## ADDENDUM No. 1

**TO:** ALL BIDDERS  
**PROJECT:** Mt Haggin WMA Tenmile Creek Boundary Fence  
FWP #7095307  
**DATE:** August 2, 2012  
**FROM:** Dan Stinson, Project Manager

**Mt Haggin WMA - Addendum No. 1 - FWP# 7095307**

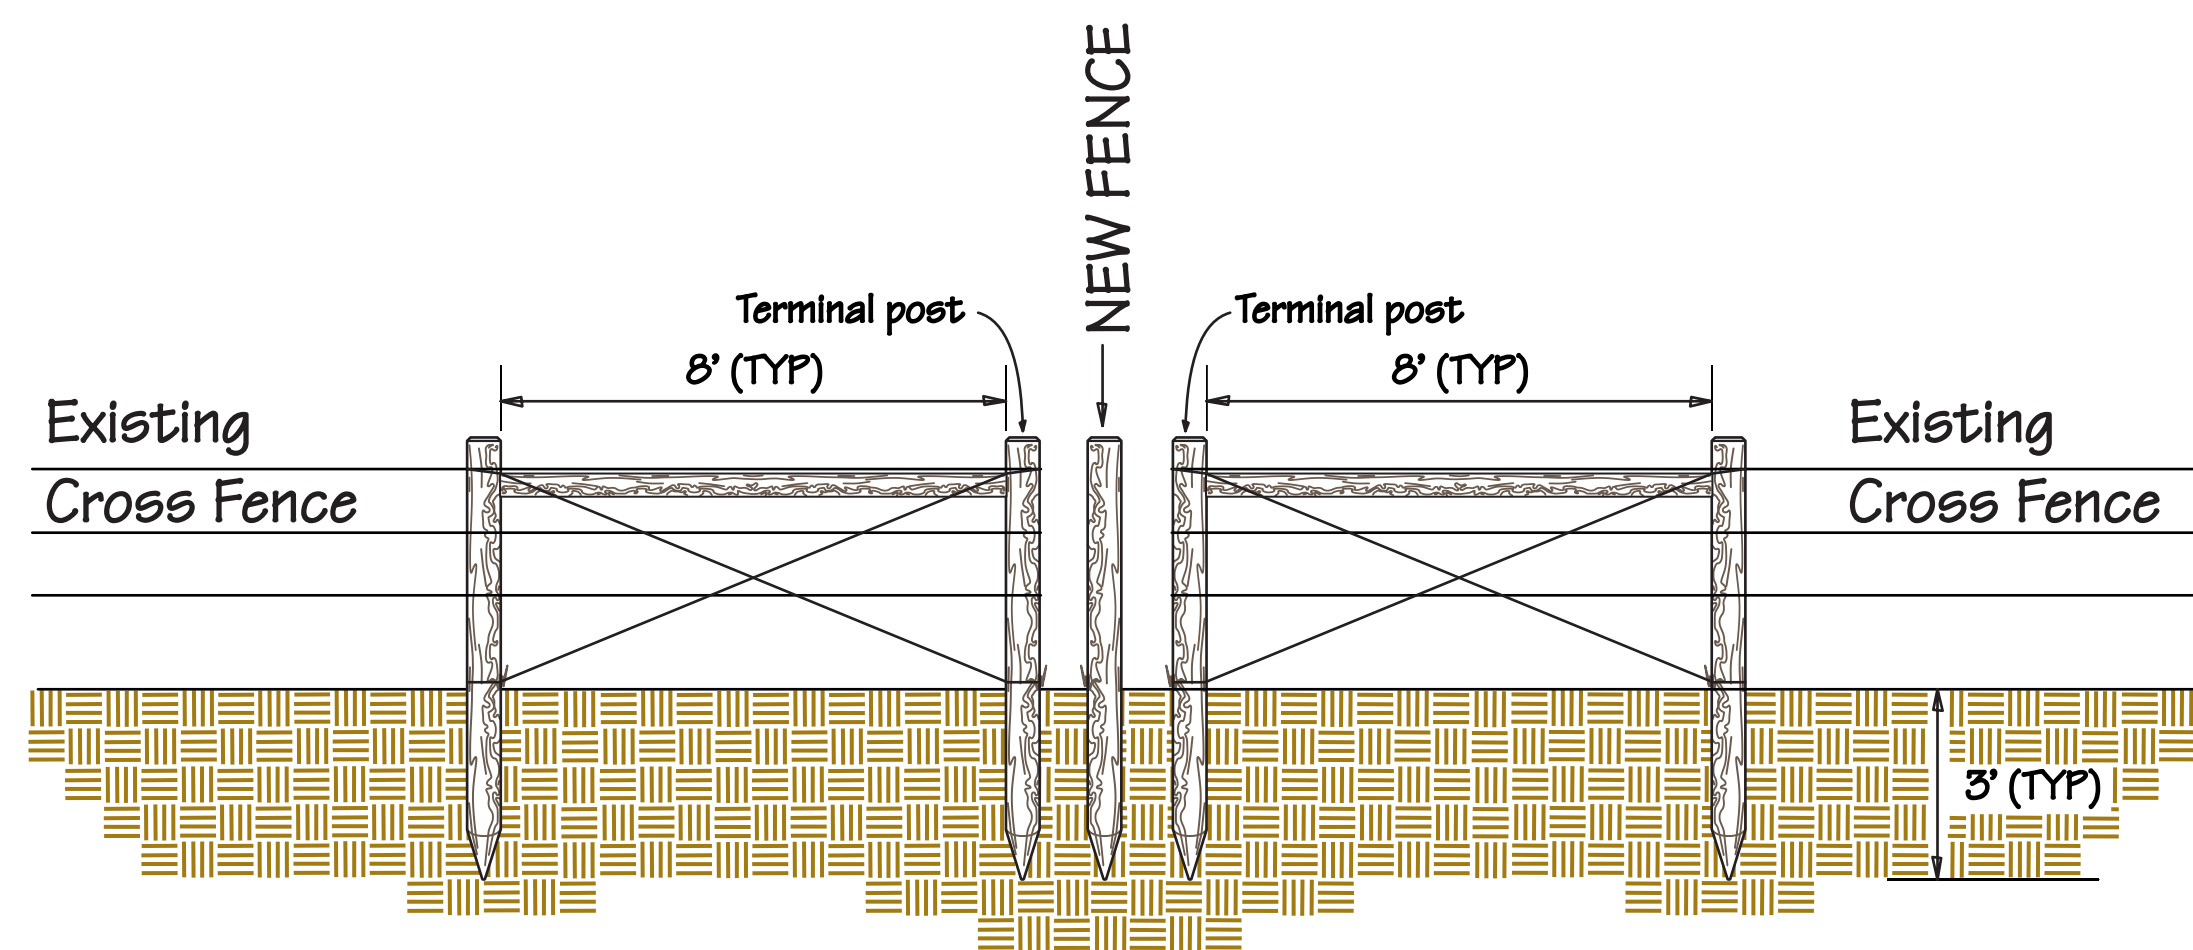
**6) Replace Section - In Technical Specifications** (page 125), in **Section 02841 - Rail Jackleg Fence**, Part 2, Section 2.1 Materials, Items A and B shall be replaced with the following:

- A. Wood jack legs shall be 5-inch minimum diameter, minimum 52" long, peeled, and **full length pressure treated** per AWP standards. Posts shall be machined, cut, and notched for universal matching. **Treating shall be done after machining.**
- B. Wood rails for jackleg fence shall be peeled with a 4 inch minimum diameter and 5 inch maximum butt and shall be 12 feet long. **Rails shall be full length pressure treated** per AWP standards. **Treating shall be done after any necessary machining.**

# INTERSECTING FENCES DETAIL

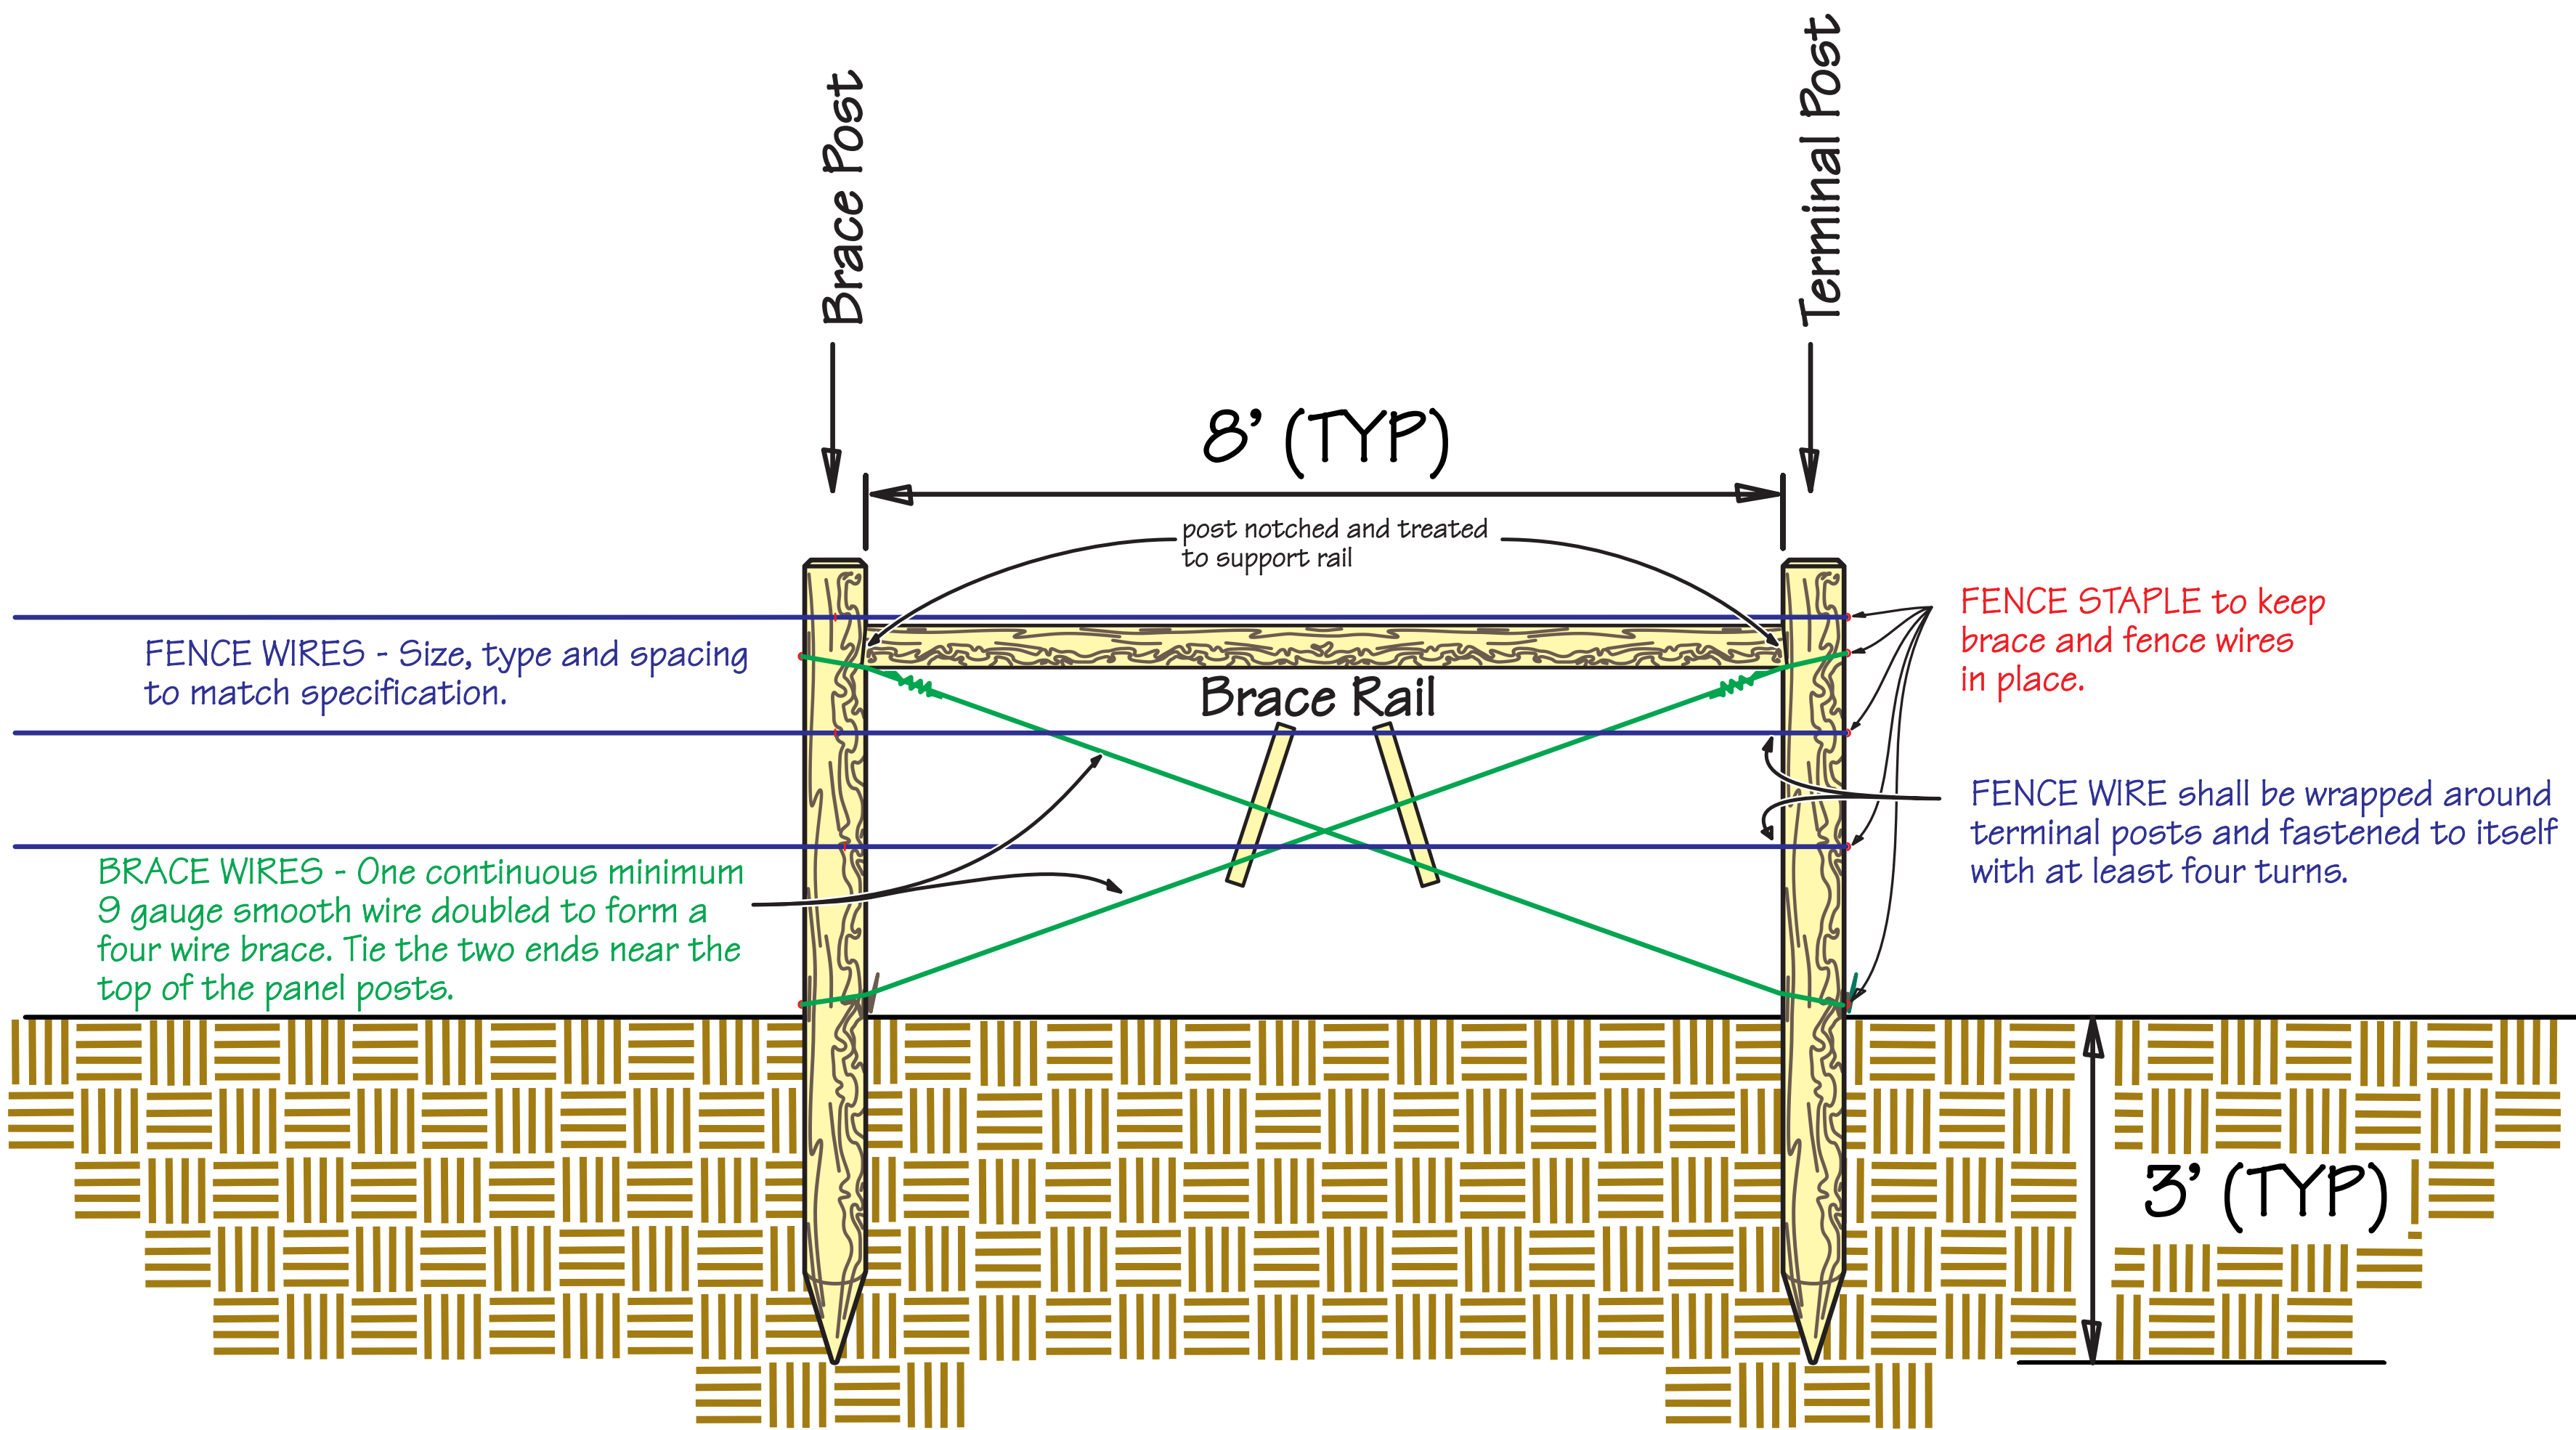
**New Item 10** is a unit cost for single panel braces to be added to existing cross fences at terminations with new fence. This is to be provided and installed in existing cross-fence adjacent to new boundary fence as shown in Addendum drawing following.

**4) Replace Section** - In **Technical Specifications** (page 121), in **Section 02810 - Fencing**, PART 3 - EXECUTION, Section 3.2 FENCE INSTALLATION, Item Q shall be replaced with the following:

Q. All cross-fences, shall **not** be fastened to the new fence but shall be terminated, in a workmanlike manner, adjacent thereto with a separate brace, as shown in the "INTERSECTING FENCES DETAIL" on the following Addendum Drawing page.

Existing intersecting fences shall be ended with a single brace.  
Single brace shall be 6" - 8" away from new fence.  
Maintain existing wire spacing on intersecting fences.
